# UNITED STATES PATENT AND TRADEMARK OFFICE

APPLICATION NO.	FILING DATE	FIRST NAMED INVENTOR	ATTORNEY DOCKET NO.	CONFIRMATION NO.
10/760,117	01/15/2004	DayNa M. Decker	62077-00008	7349

<b>Office Action Summary</b>	<b>Application No.</b>	<b>Applicant(s)</b>	
	10/760,117	DECKER ET AL.	
	<b>Examiner</b>	<b>Art Unit</b>	
	CARL D. PRICE	3749

## DETAILED ACTION

G. K. BRADFIELD.  
LAMP.  
APPLICATION FILED APR. 20, 1913.  
1,050,913. Patented Jan. 21, 1913.

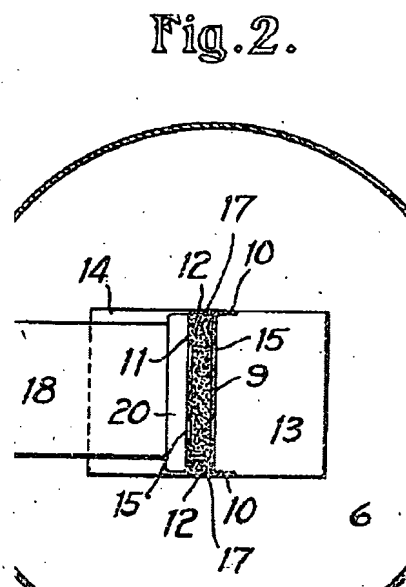
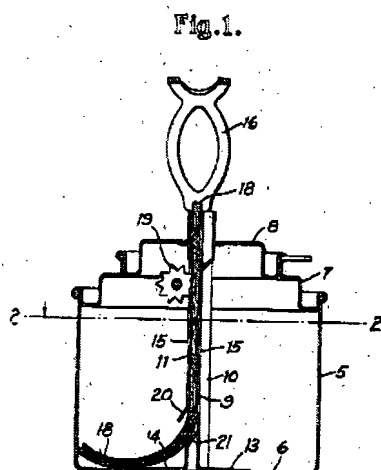
Claims **24**, **32**, **33**, **41** and **45** are rejected under 35 U.S.C. 102(b) as being anticipated by **US001050913 (Bradfield)**.

**US001050913 (Bradfield)** shows an apparatus including:

- a body defining a chamber for carrying a combustible liquid and having an open upper end;
- first and second plates (9, 11) arranged in a spaced, confronting relationship with lower portions located within the chamber of the body and upper portions; and

- a sheet wick (18) sandwiched between the first and second plates and having a lower end located in the chamber of the body, for contacting the combustible liquid,, and an upper end projecting upwardly from the upper portions of the first and second plates;

- further comprising a plurality of clips (12) positioned on side edges of the first and second plates to sandwich the sheet wick between the plates;
- wherein at least one of the clips (12) has a top portion (15) extending above and curved over the upper portion of the wick, side flanges (12) configured to hold the first and second plates and the wick together, and a bottom portion positioned in the
